## 2.3 STREAM CHANNEL MORPHOLOGY AND AQUATIC HABITAT STUDY (WTS 3)

This section presents stakeholder comments provided on the draft report, followed by the Licensees' responses. The final column presents any follow-up comment offered by the stakeholder and in some cases, in italics, a response from the Licensees.

1998 Channel Position

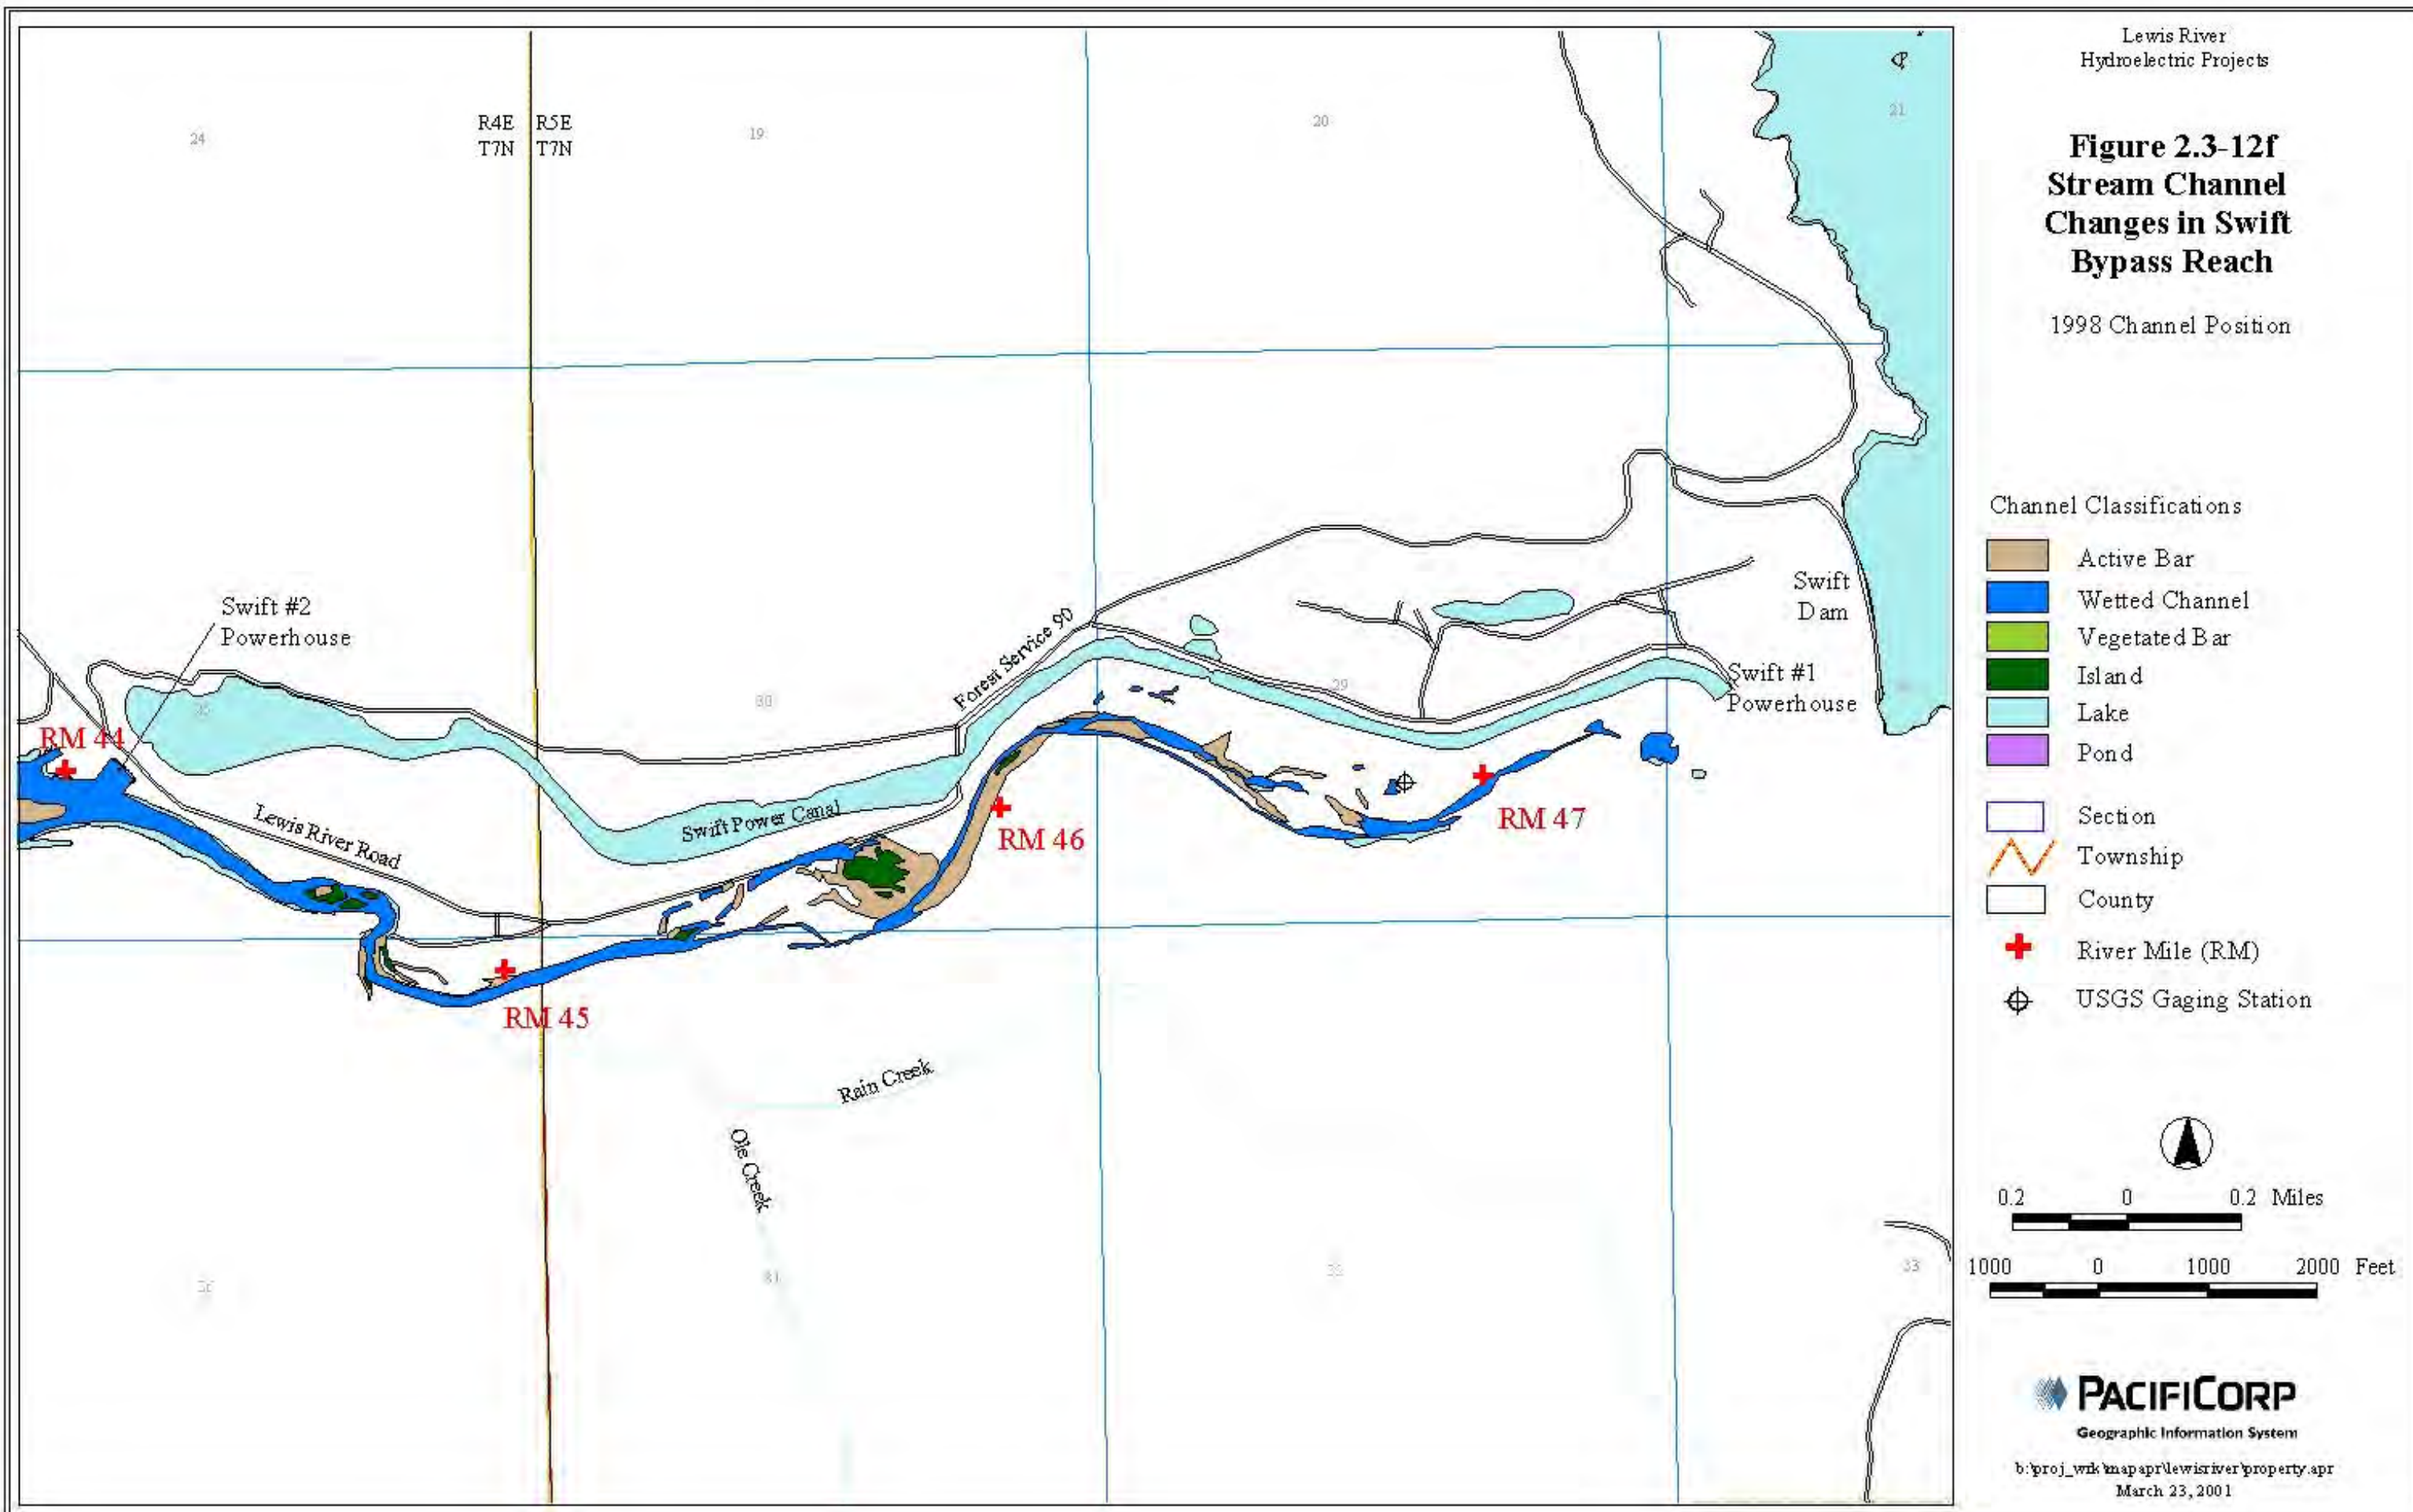
Commenter	Volume	Page/ Paragraph	Statement	Comment	Response	Response to Responses
				be stated. For example, in 1974 flows in the middle section of the reach were 8,000 cfs when the pictures were taken. With 8,000 cfs flows, some of the bar and island habitat would be under water. If so, the difference in habitat area between 1974 and 1988 actually represents an even greater habitat loss than would be apparent if the flows were equal for both photos. The effects of the uncertainties in the analysis need to be made explicit to the reader.		
WDFW – JIM BYRNE	1	WTS 03- 48 – 58	Pagination.	Pagination is incorrect, missing pages 78-91.	Figure 2.3-12 (a-f) is presented on these pages. These are 11X17 figures.	Very confusing.

**Figure 2.3-12d**  
**Stream Channel**  
**Changes in Swift**  
**Bypass Reach**

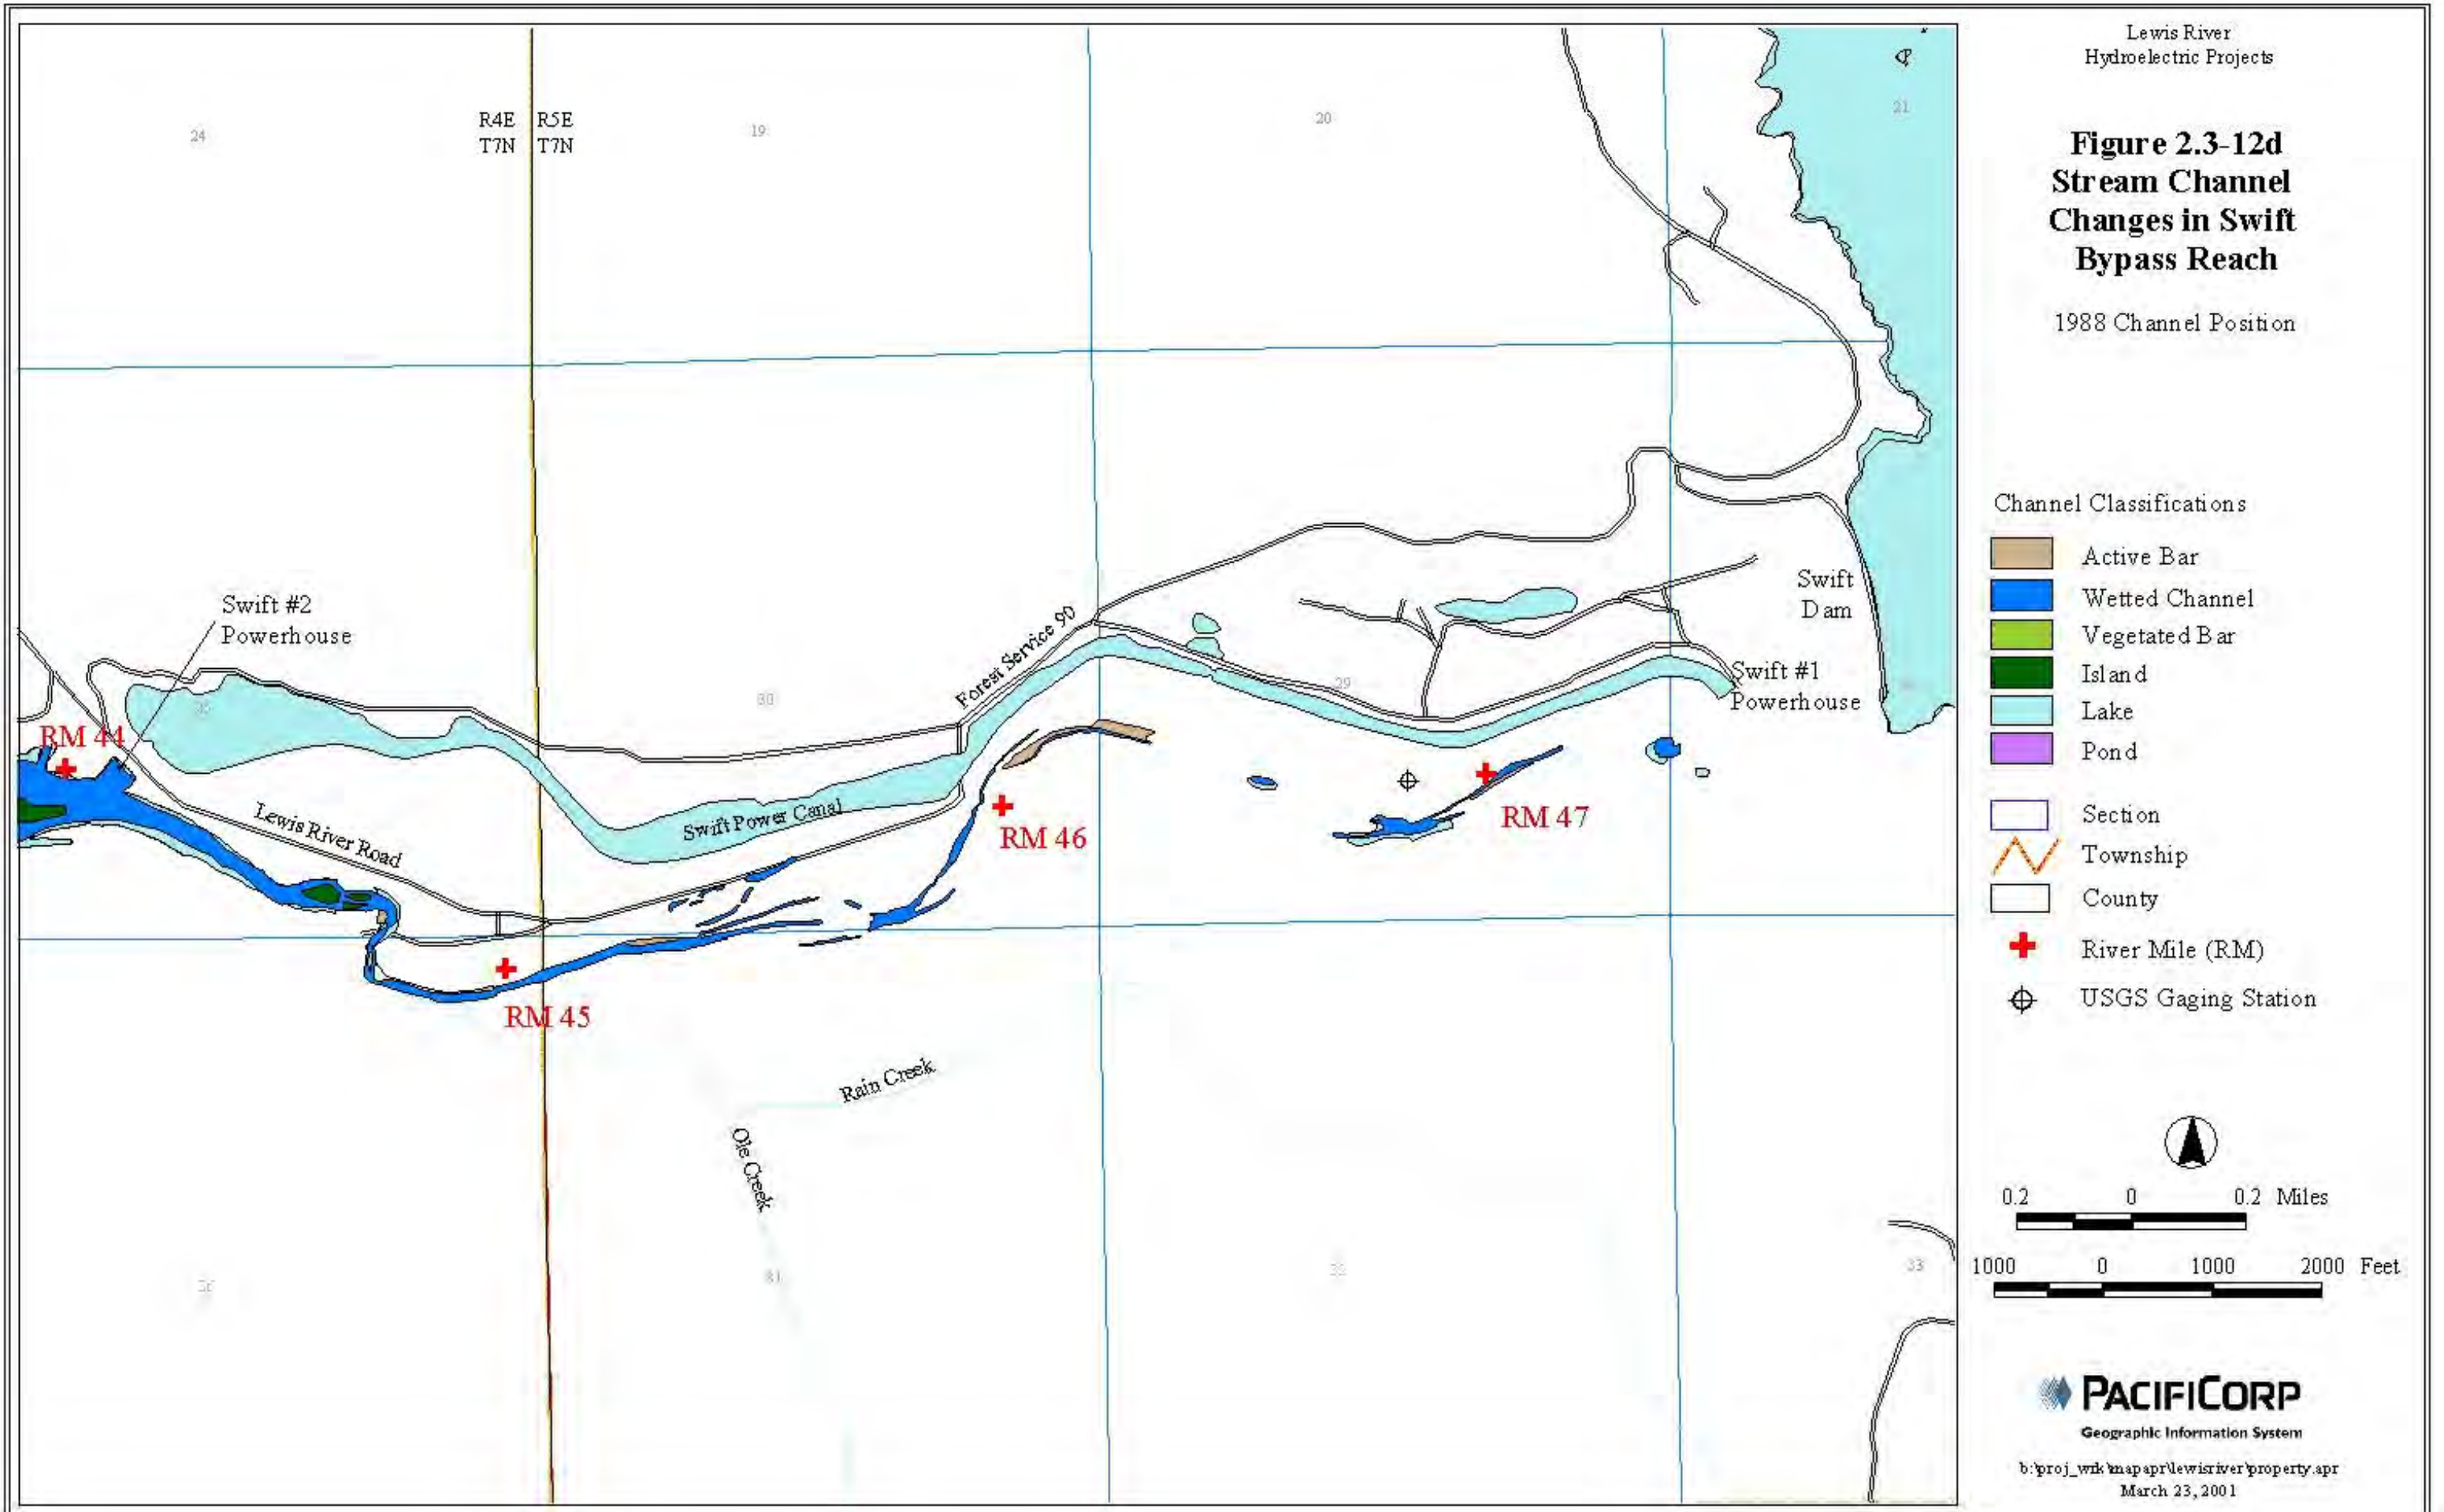
WDFW – JIM BYRNE	1	WTS 03 Fig. 2.3- 12d	Figure 2.3-12d.	In this figure the bypass channel disappears in 1998.	Figure 2.3-12d shows the Swift bypass reach mapped from 1988 aerial photographs. The discontinuous channel was mapped as a result of either coverage of the water surface	Confusing

Commenter	Volume	Page/ Paragraph	Statement	Comment	Response	Response to Responses
					by vegetation or intermittent flow at the scale of the photographs.	
WDFW – KAREN KLOEMPKE N	1	WTS 03-?	Figure for changes in cannal position over time, for Swift Bypass Reach.	This Figure is missing.	Figure 2.3-12 (a through f) was included in the original document. We regret this printing error.

**Figure 2.3-13. Gage height versus given flow for the Lewis River at Cougar gage.**

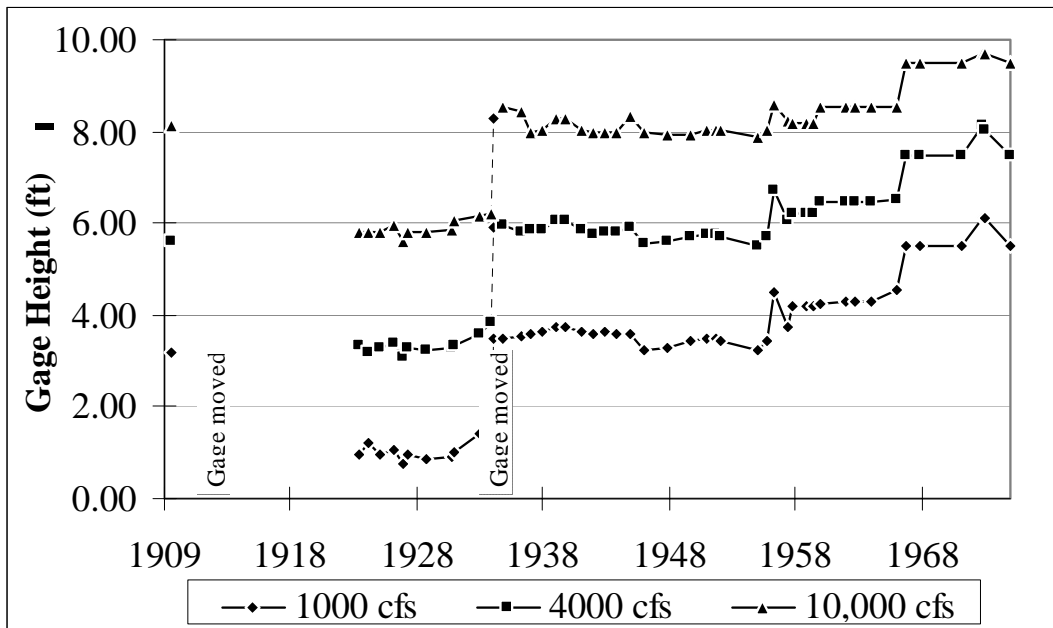
Commenter	Volume	Page/ Paragraph	Statement	Comment	Response	Response to Responses
WDFW – KAREN KLOEMPKE N	1	WTS 03- 91 Fig. 2.3-13	Gage height vs. given flow.	Missing X axis title.	The x-axis is year.	
USDA Forest Service: John Kinney and WDFW – Jim Byrne	1	WTS 03- 91 Last para	First sentence, “...Lewis river between Merwin Dam and Eagle Island...”	I think this section covered the SBR.	You are correct, the sentence should read, “The changes in median substrate size along the Lewis River <u>in the Swift bypass reach.</u> ” It will be modified.	Thank you!
WDFW – JIM BYRNE	1	WTS 03- 92	Table.	Table is mis-numbered.	Reference is made to this table on page 3-78. We believe it is numbered correctly.

**Figure 2.3-16. Gage height versus given flow for Speelyai Creek near Cougar (upstream of diversion).**

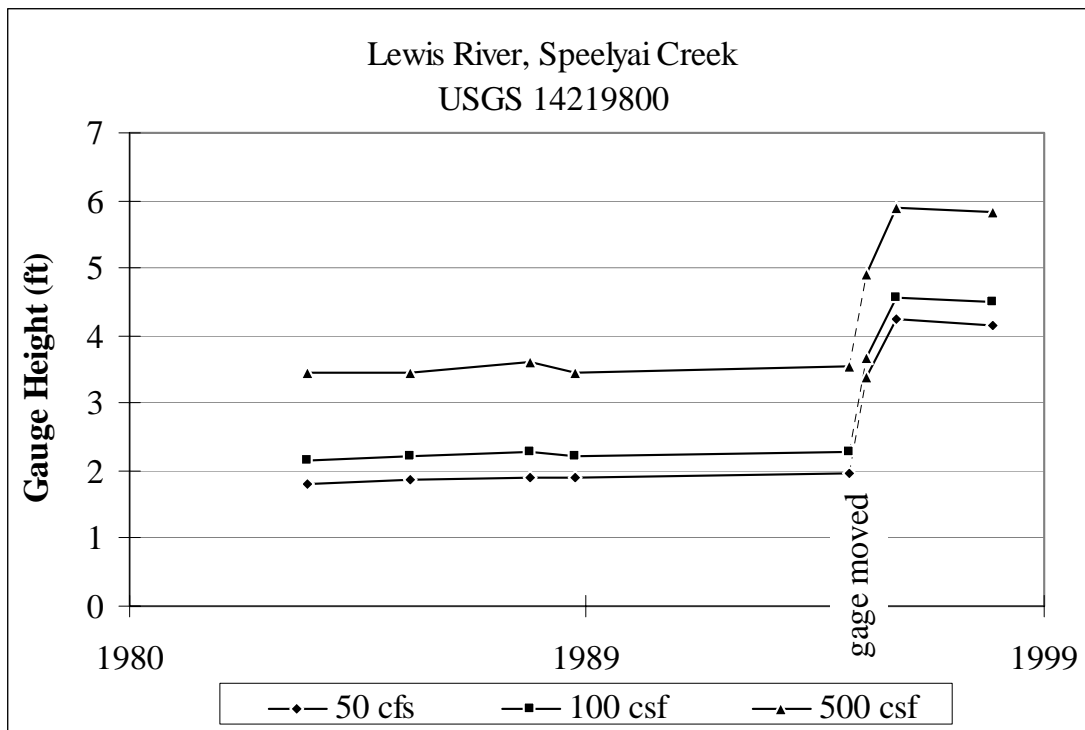
Commenter	Volume	Page/ Paragraph	Statement	Comment	Response	Response to Responses
WDFW – KAREN KLOEMPKE N	1	WTS 03- 101 Fig. 2.3-16	Gage height vs. flow for Speelyai Cr.	Missing X axis title.	The x-axis is year.

**Figure 2.3-21. Critical particle shear stress compared to computed shear stress at the Lewis River at Ariel stream gage site.**

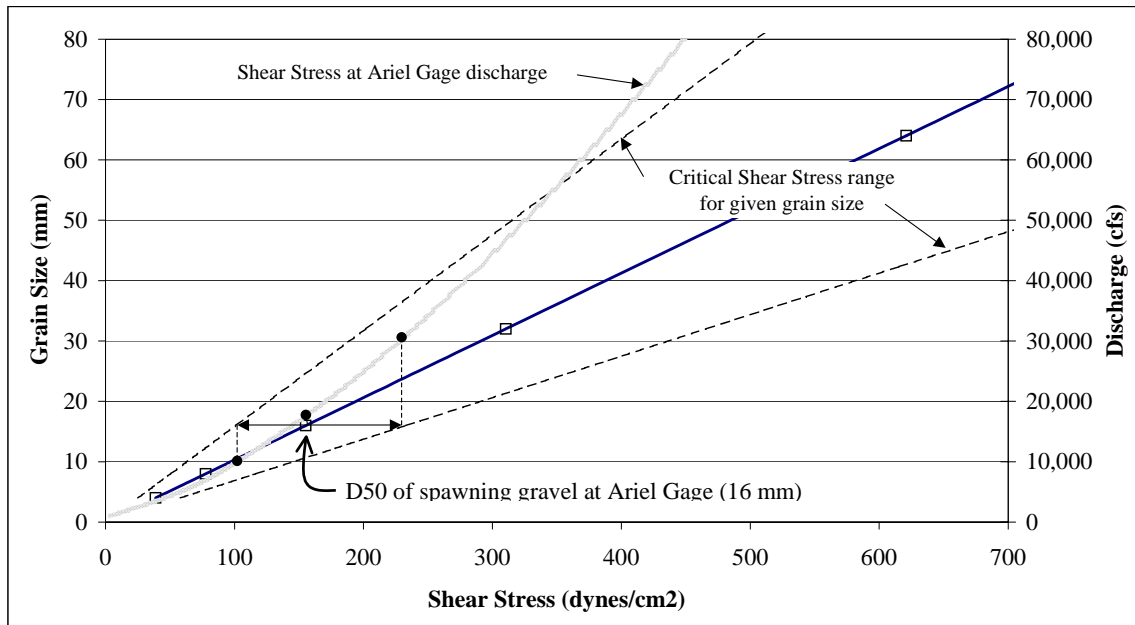
<b>Commenter</b>	<b>Volume</b>	<b>Page/ Paragraph</b>	<b>Statement</b>	<b>Comment</b>	<b>Response</b>	<b>Response to Responses</b>
J. Sampson, Technical Advisor to the Conservation Groups	1	WTS 03- 111 equation 2	“C = a constant, defined as 0.039 to 0.09 by different researchers”	The value of the constant used by the authors in subsequent calculations should be identified and a rationale for its use should be provided with a citation to the primary literature.	The range of C values (0.039 to 0.09) was used to provide the “Critical Shear Stress range” in Figure 2.3-21 and in subsequent discussions on Page WTS 3-112.
